Docket Nos. 50-282  
50-306

In response to items 19, 20, 21 and 22 of your request dated May 24, 1974 and your request dated February 17, 1976, the Commission has issued the enclosed Amendment Nos. 11 and 5 to Facility Operating License Nos. DPR-42 and DPR-60 for Units 1 and 2 of the Prairie Island Nuclear Generating Plant.

PRAIRIE ISLAND NUCLEAR GENERATING PLANT UNIT NO. 1

ATTACHMENT TO LICENSE AMENDMENT NOS. 11 AND 5  
FACILITY OPERATING LICENSE NOS. DPR-42 AND DPR-60  
DOCKET NOS. 50-282 AND 50-306

FIGURE TS.4.10-1

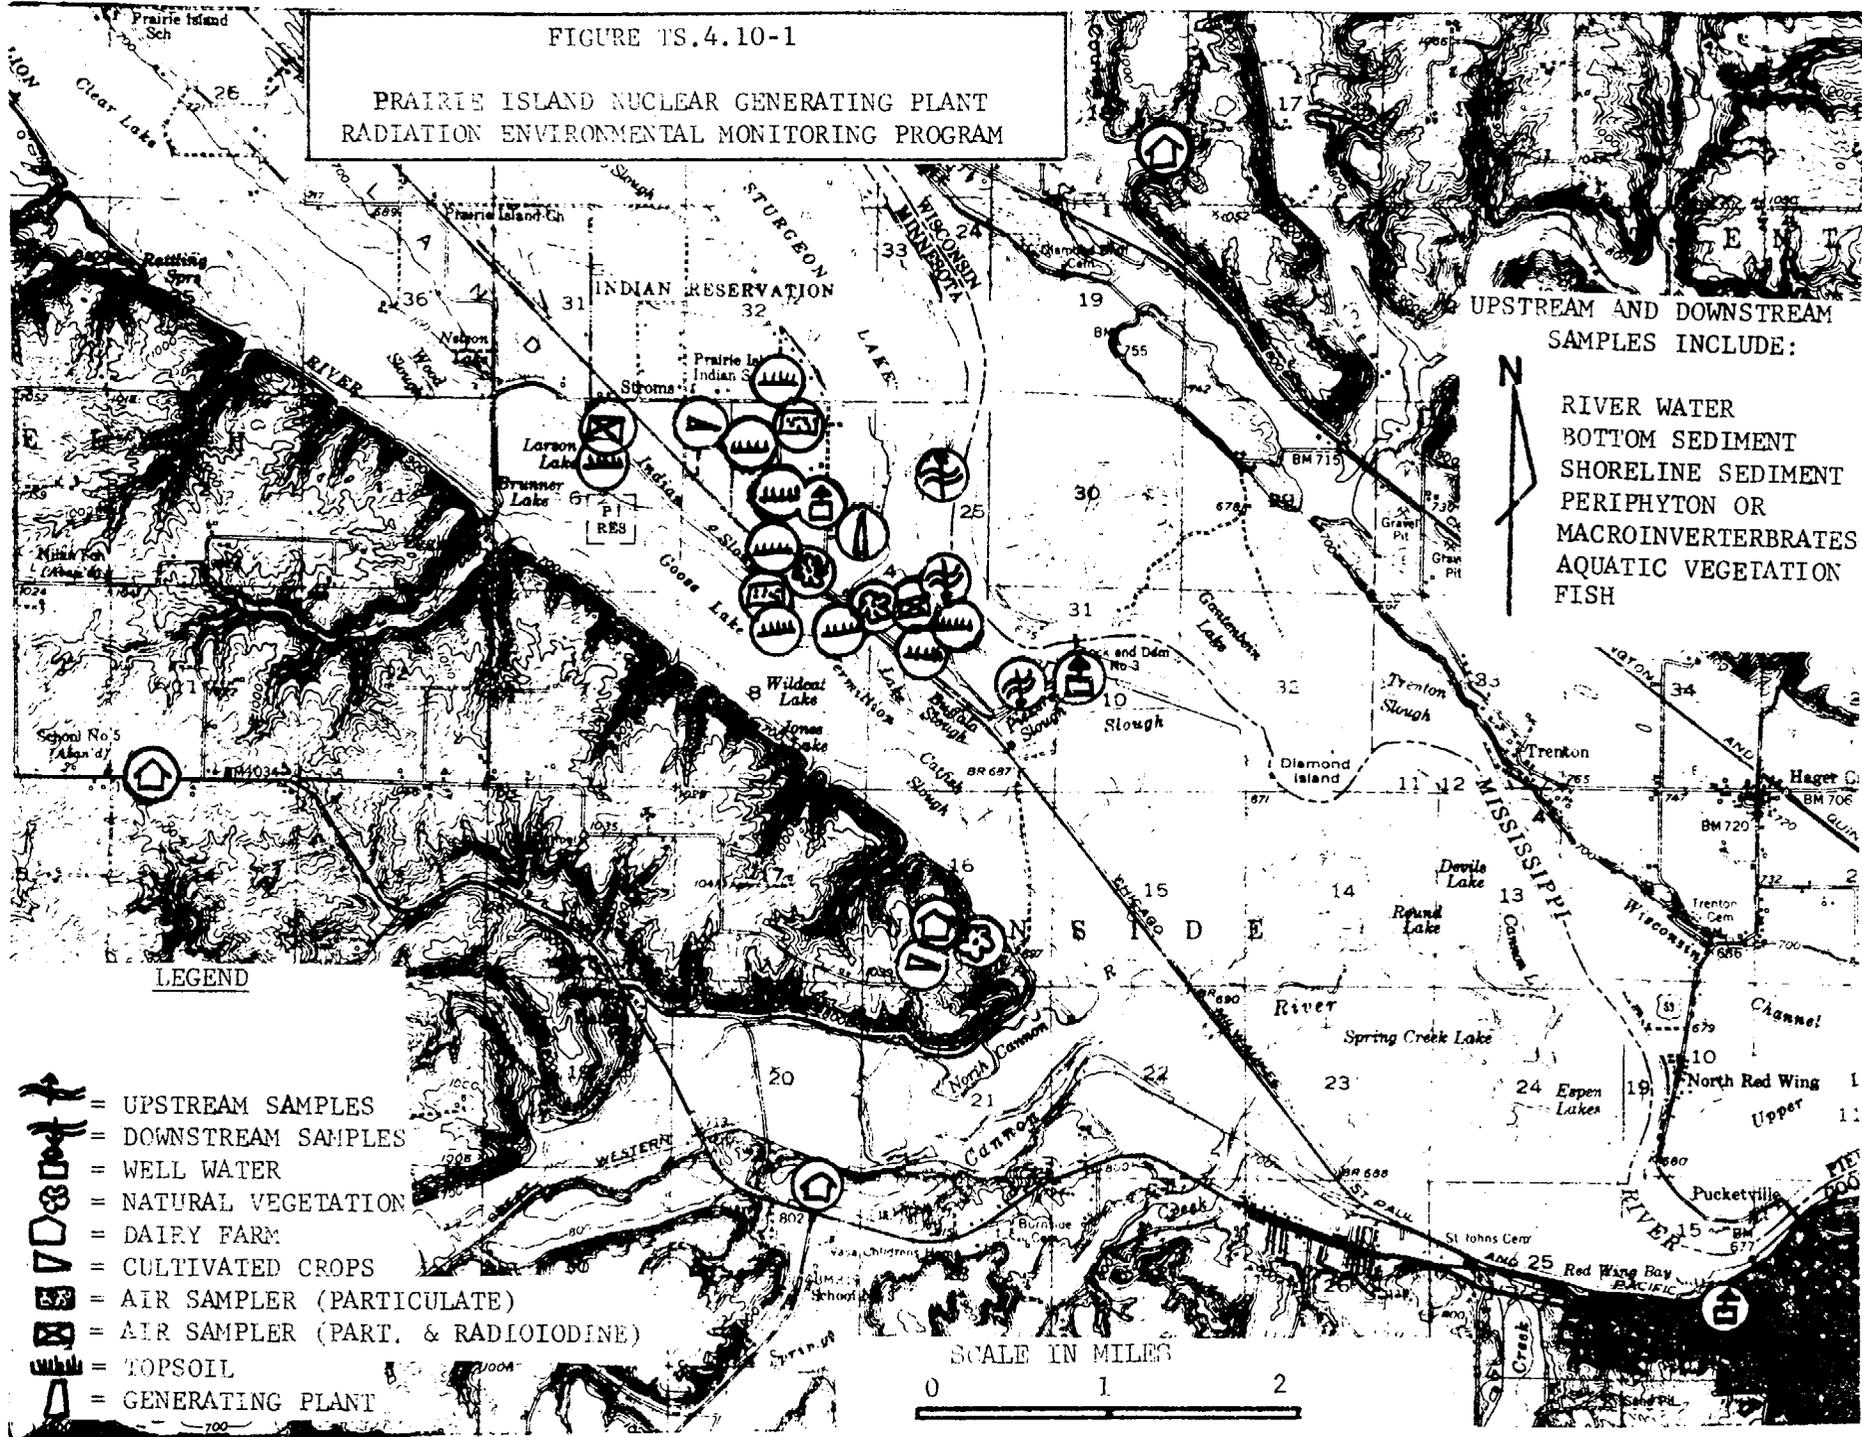
The proposed change dated February 17, 1976, involves changes in environmental samples, sample locations and sampling frequencies which are contained in Section 4.10 "Radiation Environmental Monitoring Program".

The proposed changes in Section 4.10 involve changing samples, sample frequencies and sampling locations. The proposed changes would revise requirements which were found to be impractical and update the monitoring program to include more current regulatory guidance. Based on our review of the program we find that the changes would result in providing equivalent or better information on radioactivity releases than the existing program.
